UNITED STATES PATENT AND TRADEMARK OFFICE

APPLICATION NO.	FILING DATE	FIRST NAMED INVENTOR	ATTORNEY DOCKET NO.	CONFIRMATION NO.
10/500,395	06/24/2005	David Chow	285-237 PCT US	9017

Office Action Summary

DETAILED ACTION

Figure 1

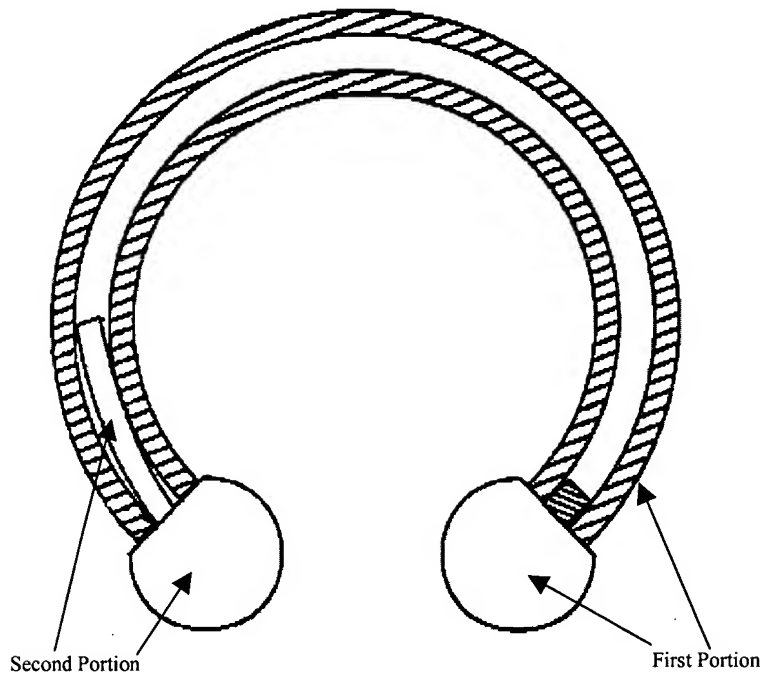
Regarding claim 1, Siekierski discloses a device comprising a first portion and a second portion displaceable relative to the first portion and detachably coupled therewith in a locked position (see Figure 1 below). Regarding claim 22, Siekierski discloses a device wherein the first and second portions each have curved cylindrical bodies dimensioned so that the cylindrical body of the second portion is slidably disposed within and extending through the cylindrical body of the first portion, a distal end of the second portion being enlarged to abut a distal end of the cylindrical body of the first portion. Regarding claim 23, Siekierski discloses a device wherein the proximal end of the cylindrical body of the first portion has an enlarged head capable of abutting an outer surface of bone fragments and wherein the distal end of the first body is capable of being forced outwards to abut an outer surface of another bone fragment in response to a tensile force applied to a proximal end of the second portion.
